PARTS & SERVICE

REF NO.	AT04077
DATE	Apr. 20, 2004
(C)	Page 1 of 6

SUBJECT: MODIFICATION PROCEDURE FOR ENGINE MUFFLER ON WA100-5/

WA150-5 (WITH CABIN)

Fig. 1

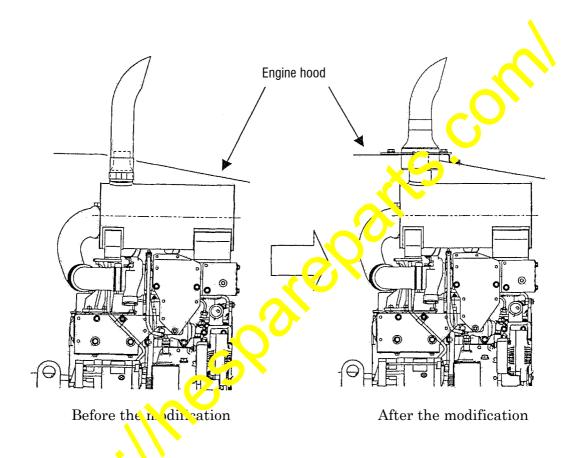
The exhaust pipe installation structure has been changed to the structure to install the exhaust pipe to the engine hood from the structure to install it to the muffler directly.

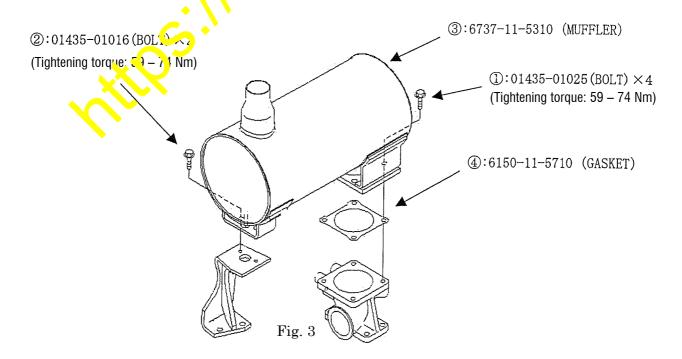
It is not necessary to replace the mufile, but install the exhaust pipe as per Section
 (4) "Installation of the exhaust pipe".
- (3) Replacement of the muffler
- (3)-1 Remove the bolts ① (01435-01025) and bolts ② (01435-01016), and replace the muffler ③ (6737-11-5310) and be sasket ④ (6150-11-5710).
- (3)-2 Tighten the bolts (1) and bolts (2). (Tightening torque: 59 74 Nm)

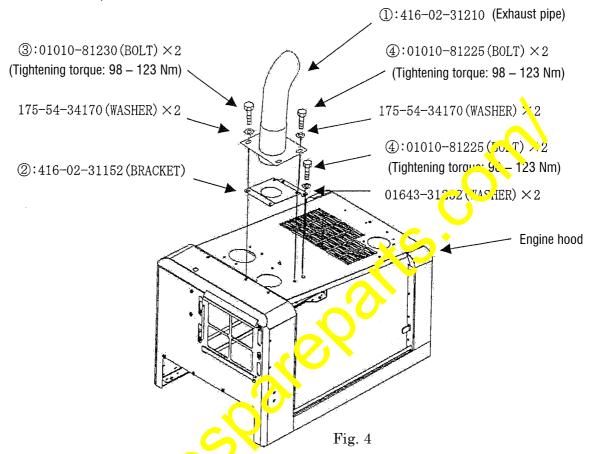
- (4) Installation of the exhaust pipe
- (4)-1 Install the exhaust pipe ① (416-02-31210) and the bracket ② (416-02-31152) to the engine hood. (Observe the <Precautions for the installation work> indicated below.)
- (4)-2 Tighten the bolts 3 (01010-81230) and bolts 4 (01010-81225). (Tightening torque: $98-123~\mathrm{Nm}$)

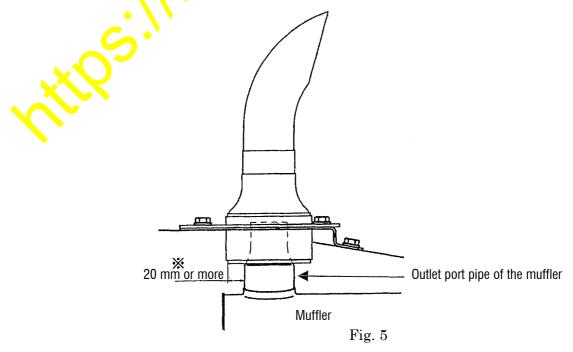
Install the above parts (1) (no. (2) securing a circumferential clearance (**) of 20 mm or more around the outlet port pipe of the muffler.
